# TECHNICAL INFORMATION

**SUBJECT: Bolt on ECHO CS-490ES, CS-501SX and shindaiwa 501sx**

**Number: Y2017-632  
Issued: Aug. 31, 2017**

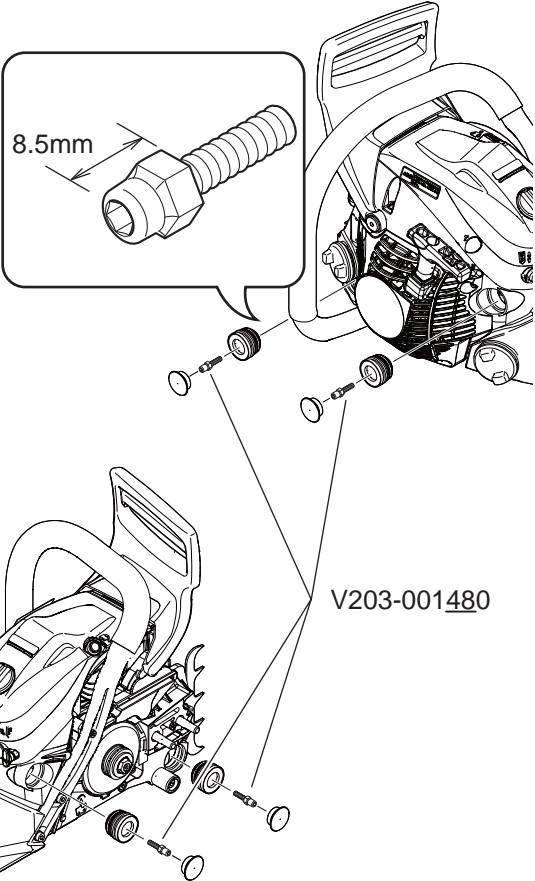
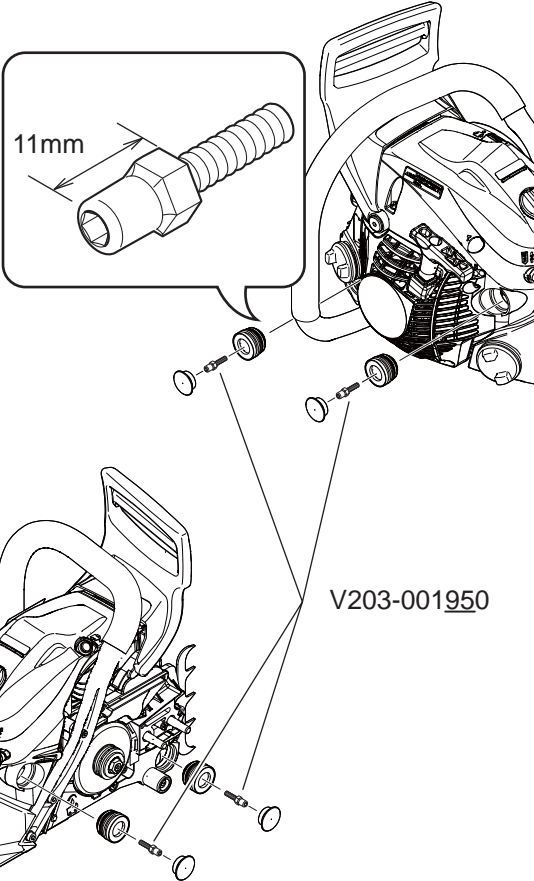
Shape of cushion mounting bolt was changed to reduce load on the cushion.

<b>CS-490ES(37)</b>	Serial Number 37003160 and before	Serial Number 37003161 and after
<b>CS-501SX(37)</b>	Serial Number 37007060 and before	Serial Number 37007061 and after
<b>501sx(37)</b>	Serial Number 37005700 and before	Serial Number 37005701 and after
Bolt	 <p>V203-001480</p>	 <p>V203-001950</p>
<p>Bolts V203-001950 can be used on the unit before this change. When changing the cushion, the all four cushions and bolts should be replaced.</p>
